DEVELOPMENT REVIEW BOARD  
SUPPLEMENTAL SUBMITTAL

PROJECT NO. 2018-001579

SUBMITTAL DESCRIPTION: Departmental comments indicated a number of items to be addressed in a deferred hearing date, indicated above for multi-family apartments project at 7500 Indian School Rd in the Winrock Town Center. Responses to the comments and revised sheets are provided.

This letter outlines the modifications that have been made to the Apartments at Pennsylvania St and Indian School Rd application for a major site plan amendment to the approved Winrock Town Center Site Development Plan (PR-2018-001579) to address the agency comments that were received.

TITLE: **CONCEPTUAL ENLARGED UTILITY PLAN**

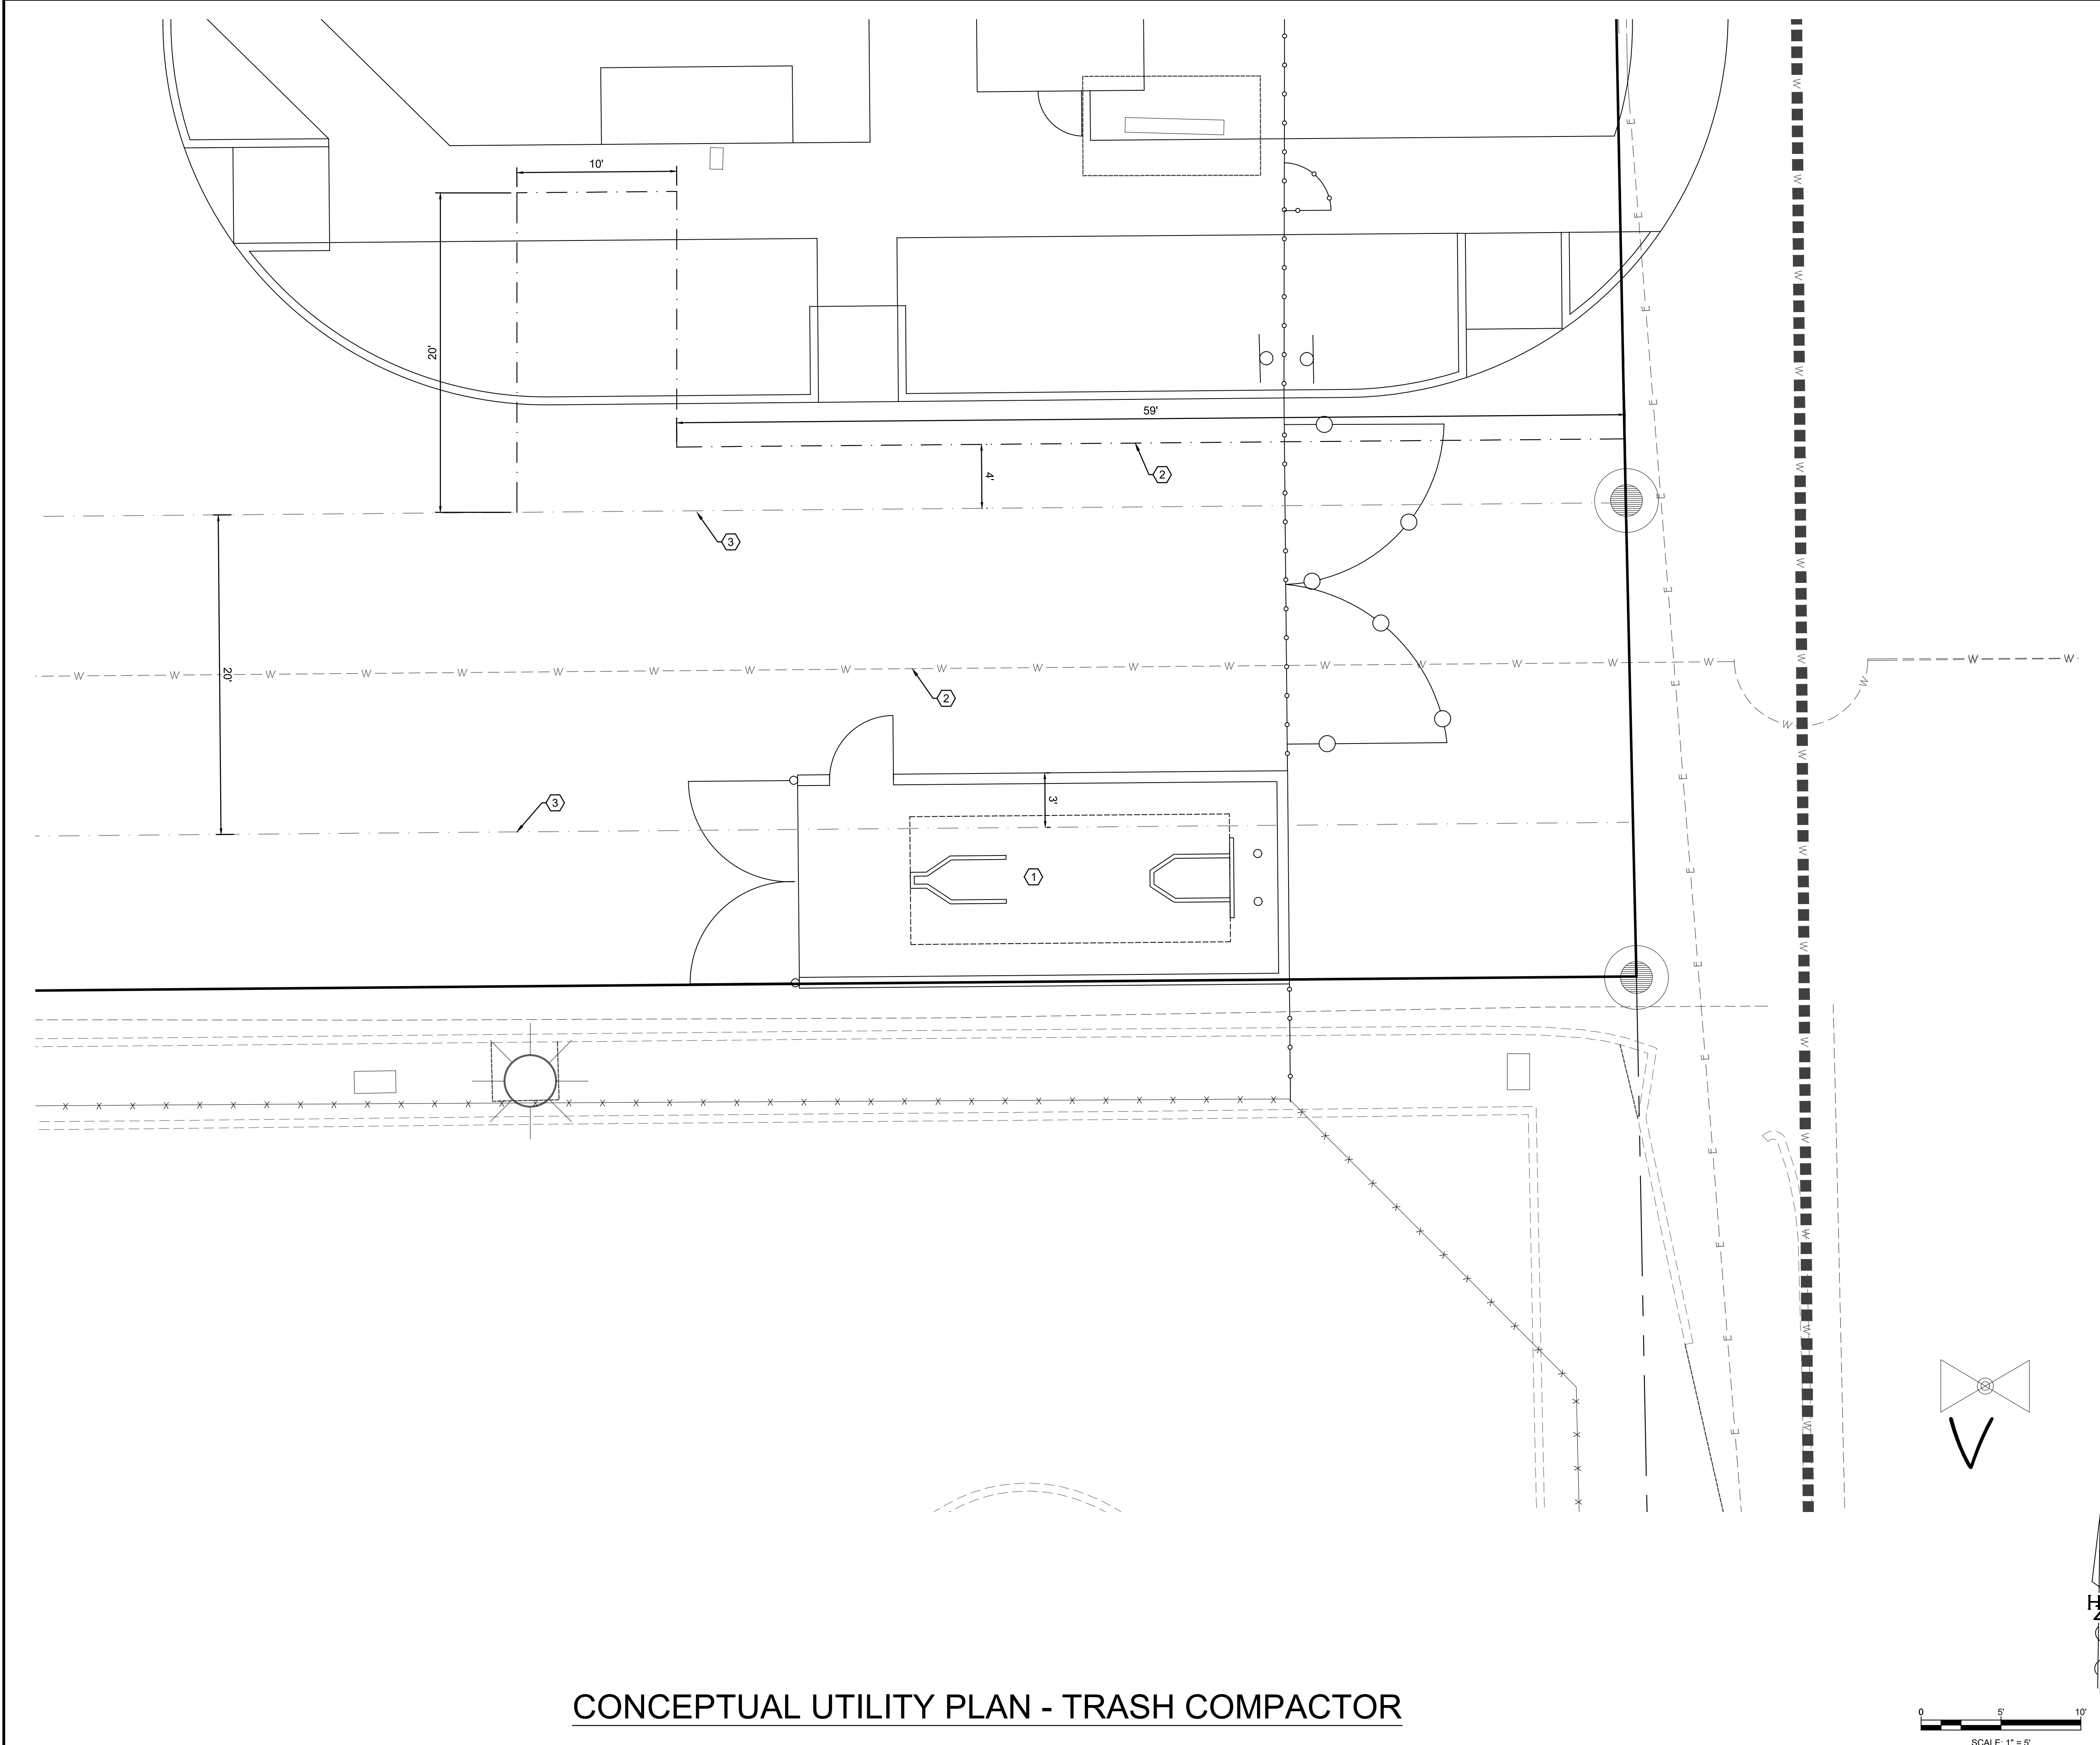
- c. Utility Plan
  - i. Response to comments indicated a new fire one plan was submitted to fire marshal’s office to take into fire suppression system and possible reduction of the required 6,000 gpm, which was analyzed in the availability statement. Approval will be contingent upon the analysis of the new fire one plan, with updated fire flow and fire hydrant connection points.

- ii. Please indicate if the Keyed Note #6 sanitary yard line has any connections from Parcel K. If so, the public sanitary sewer (Keyed Note 11) shall be extended so that Parcel K can connect to the public sanitary sewer.

- iii. PREVIOUS COMMENT: All proposed fire hydrants onsite shall be labeled as private. Fire hydrants in public right-of-way shall be labeled as public. The response to comments concurred, however FH#3 and FH#2 are labeled as public fire hydrants. Please label as private. FH#6 is not labeled and shall be private. FH#8 is not labeled and shall be public.

- iv. PREVIOUS COMMENT: Demonstrate a private easement for the private fire hydrant #3, given that the waterline being connected to is on another parcel. Alternatively you may show this waterline connecting to the public main on Tract E-1-A.

- vi. Keyed note #6 and #7 point to the same private sanitary sewer, however one is existing and the other is proposed. Please confirm the termination of the existing private sanitary sewer. Please label the sanitary sewer as being private.

*Still waiting on Fire Marshall office for revised plan.*

*Utility plans have been updated.*

*Utility plans have been updated.*

*Utility plans have been updated.*

*Utility plans have been updated.*

TITLE: **CONCEPTUAL UTILITY PLAN  
 TRASCH COMPACTOR EXHIBIT**

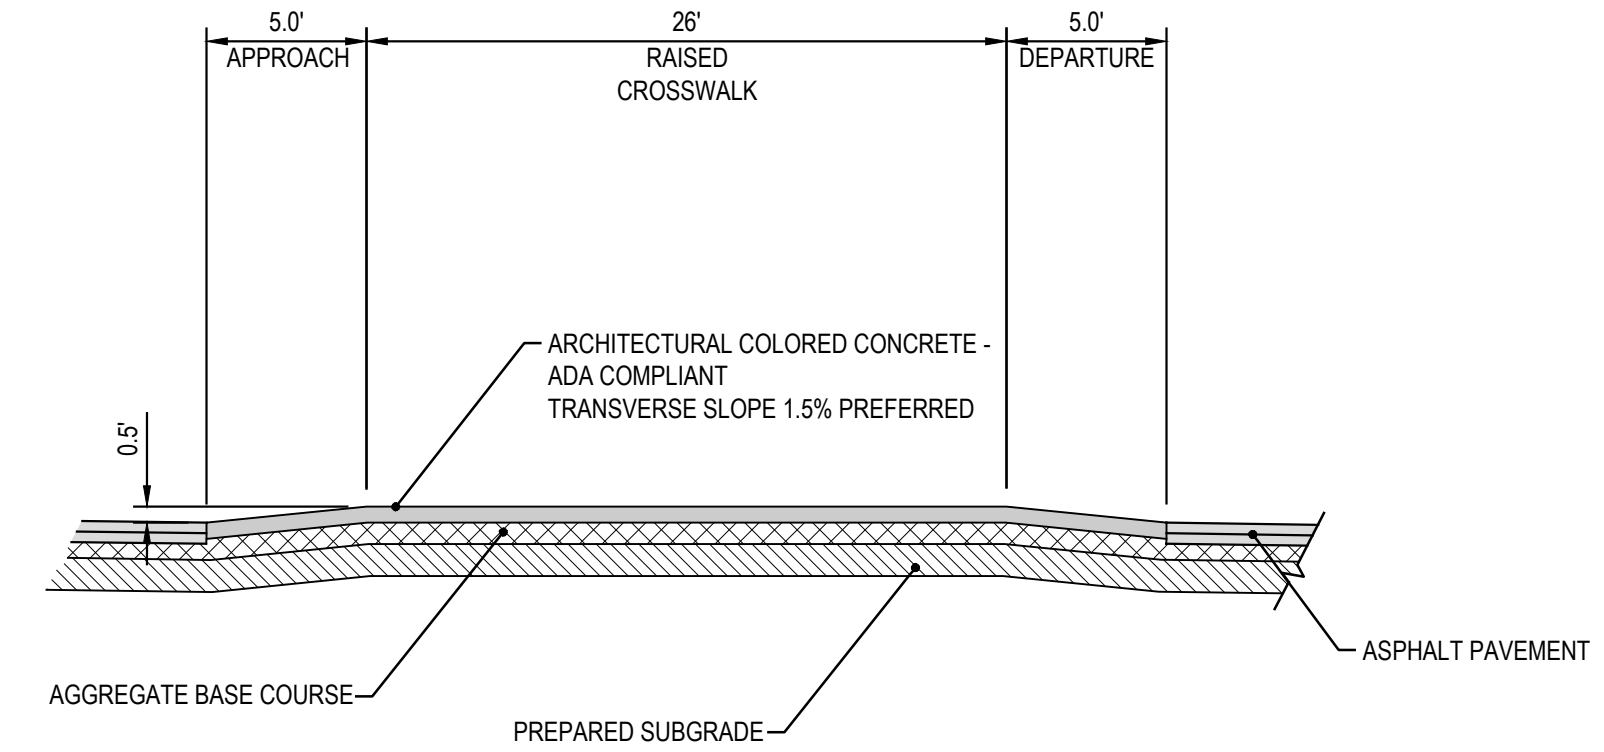
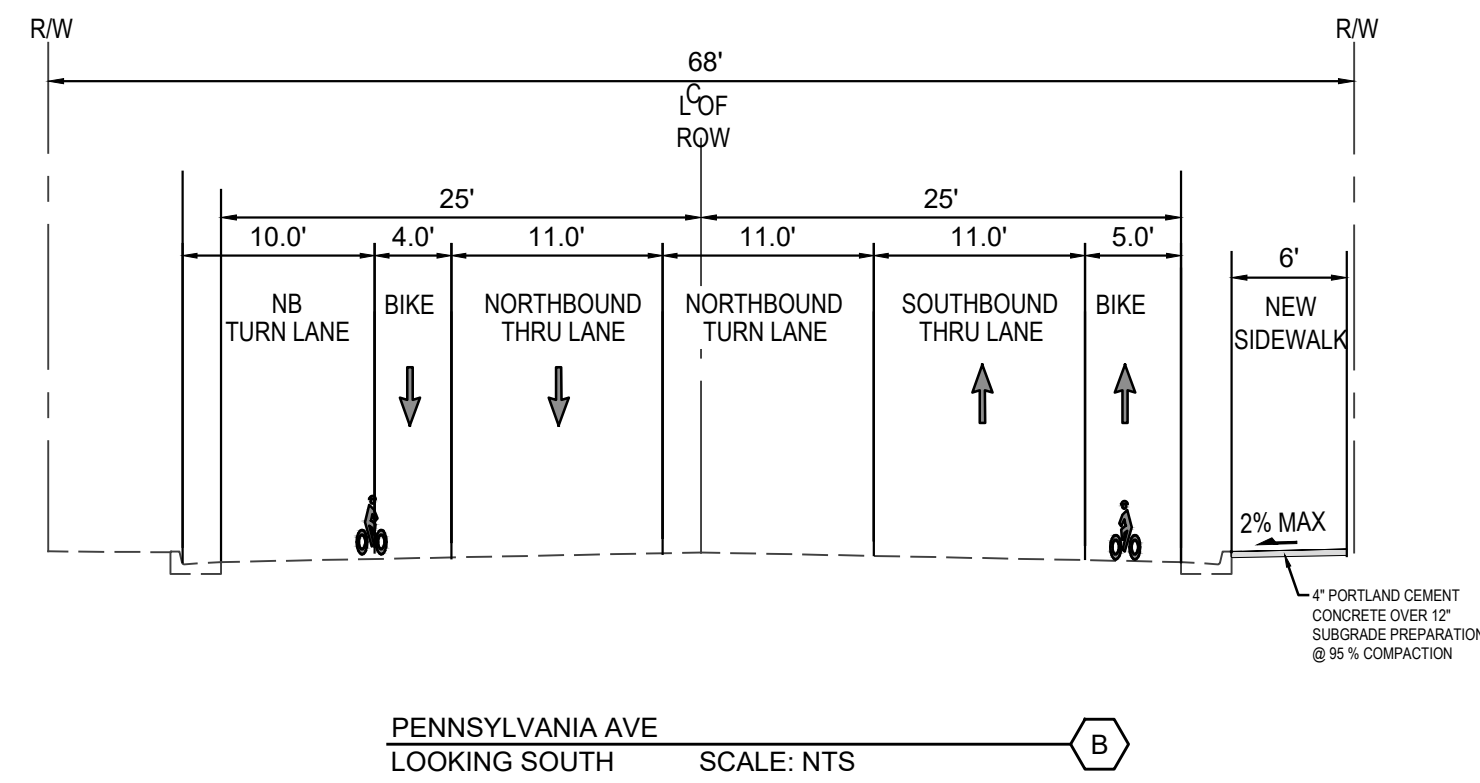
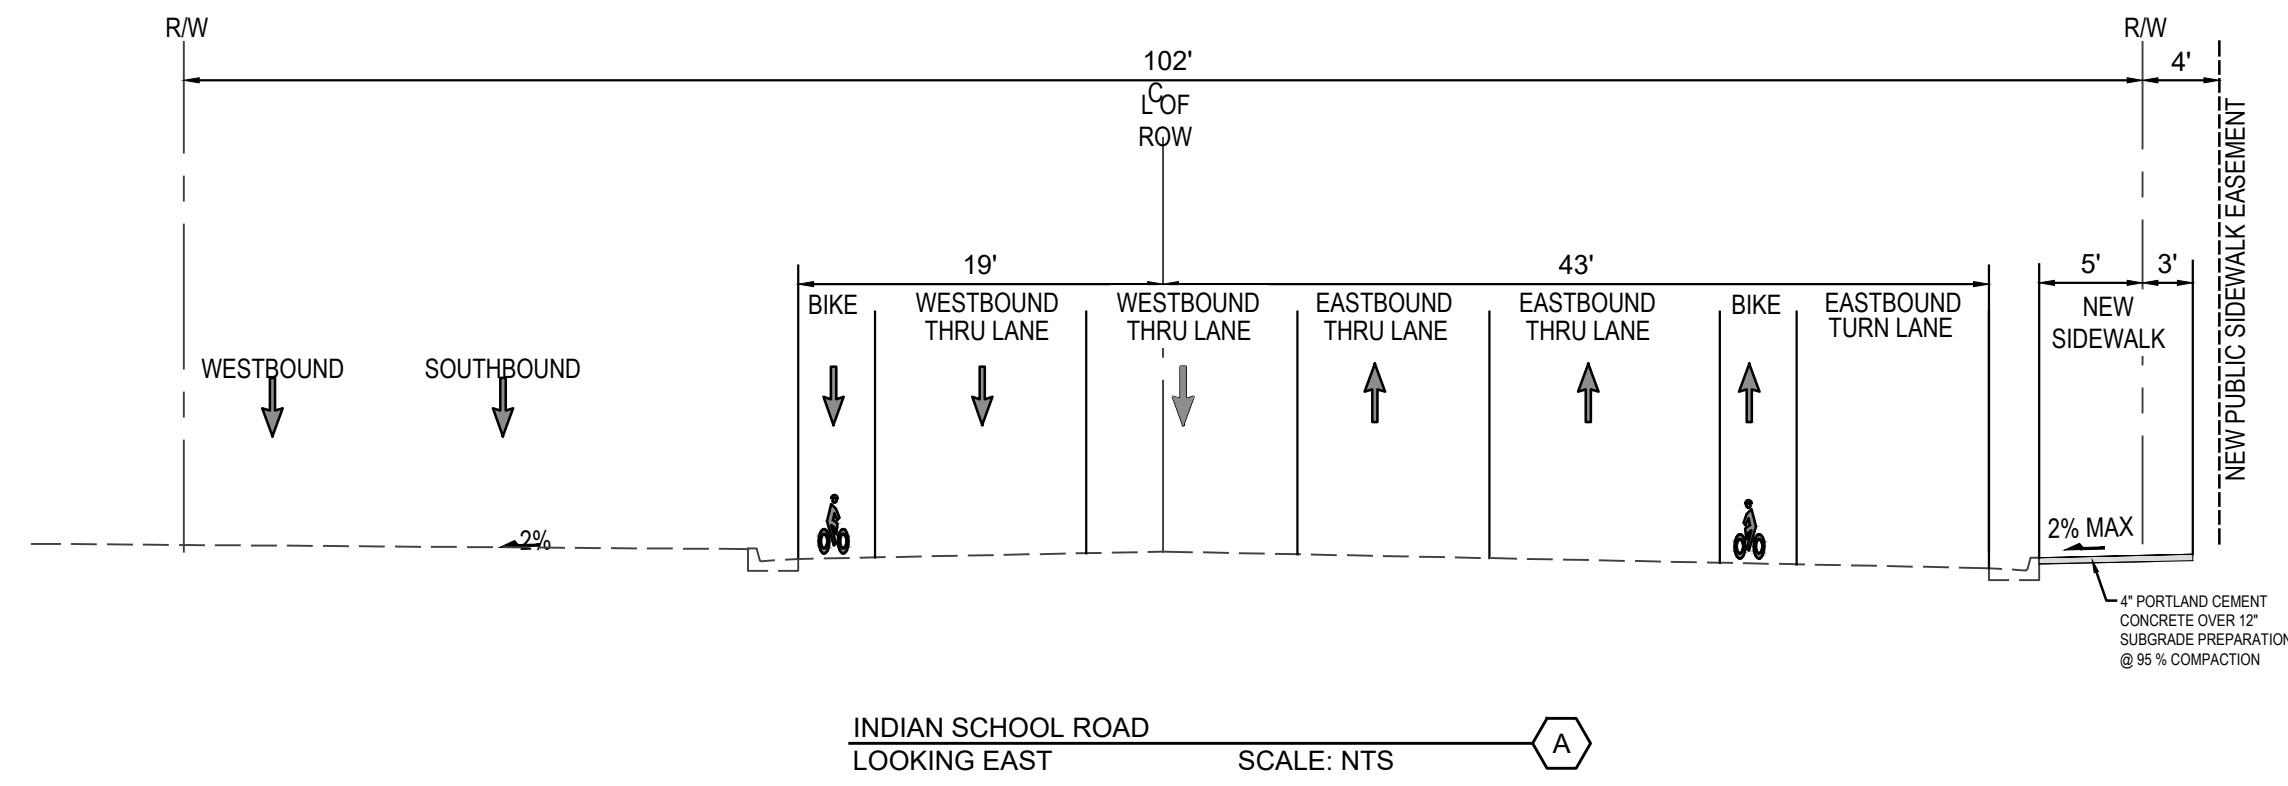
- ii. The proposed trash compactor (keyed note #41) cannot encroach into the public waterline. Please relocate.

2. See above comment regarding the enclosure and trash compactor being within the public waterline easement.

3. There is a gate shown at the east end of this public waterline easement (keyed note #30). The post for this gate is conflicting with the water main location. Relocate the gate so the 20.00' gate spans the easement.

*Trash compactor is at least 6-feet clear of the existing public waterline. Application grants additional ABCWUA waterline easement to the north.*

*Please refer to sheet C202 – Trash Compactor exhibit.*

*Gate has been shifted. Gate and trash compactor is at least 6-feet clear of the existing public waterline.*

TITLE: <b>SITE DETAIL</b>	
Design Review Committee	City Engineer
City Project No. <b>XXXX.XX</b>	Zone Map No. <b>J-19</b>
Sheet <b>C400</b>	Of

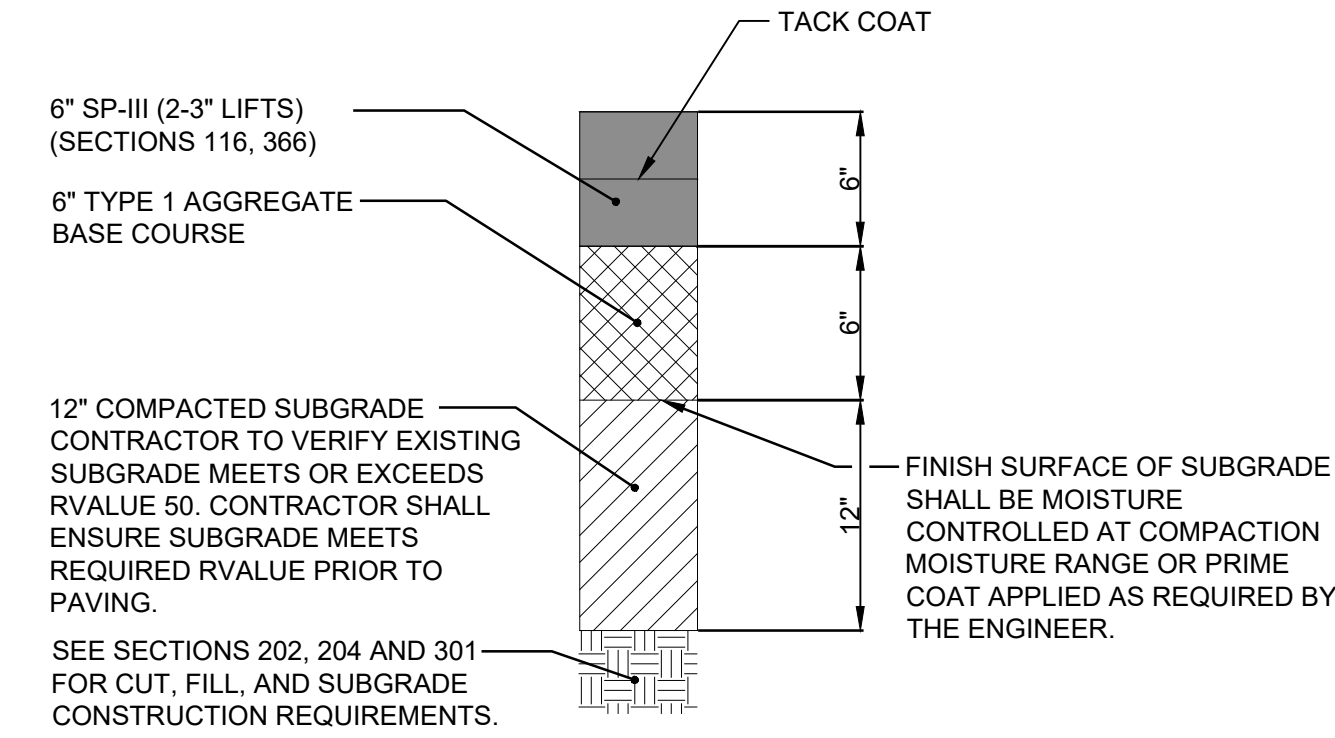
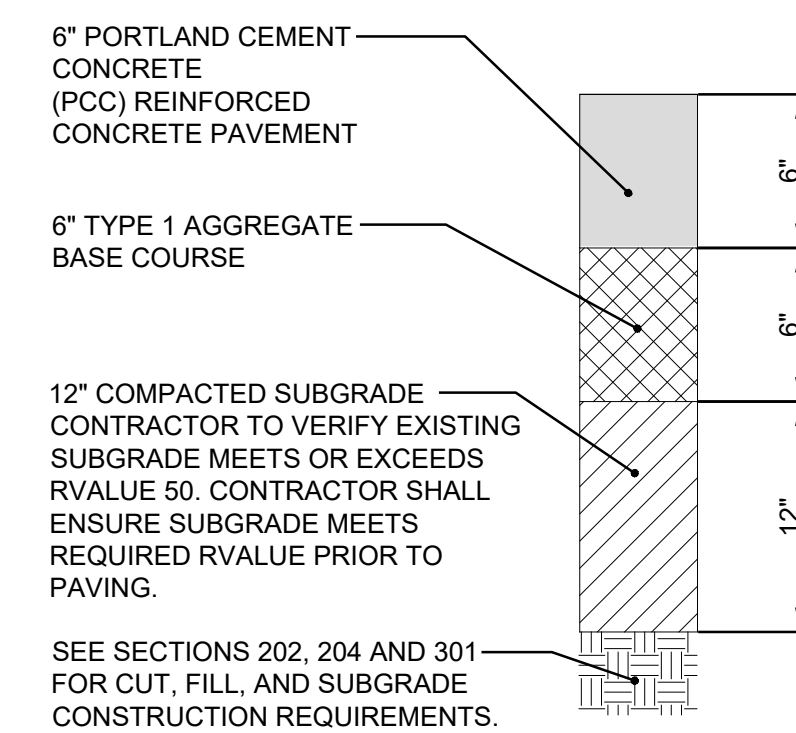
3. For the cross-section on Pennsylvania, show bike lane width and all lane widths prior to platting approval.

6. Provide updated detail sheet along with submittal. Include width of raised crosswalk, curb ramps etc. Include “Yield to Pedestrians” signage for the wide crosswalk.

*Cross-section on Pennsylvania with dimensions included on sheet C400.*

*Site detail sheets are included. Per previous discussion, the intersection with raised pedestrian crossing is designed as three-way stop intersection and stop signs are provided. Per note 39 pedestrian crossing signage is provided at the raised crossing. This signage is revised to include “yield to peds” – see site detail sheet. Accessible pedestrian ramps width vary and follows the width of sidewalk. Minimum width used is 5'-0”.*
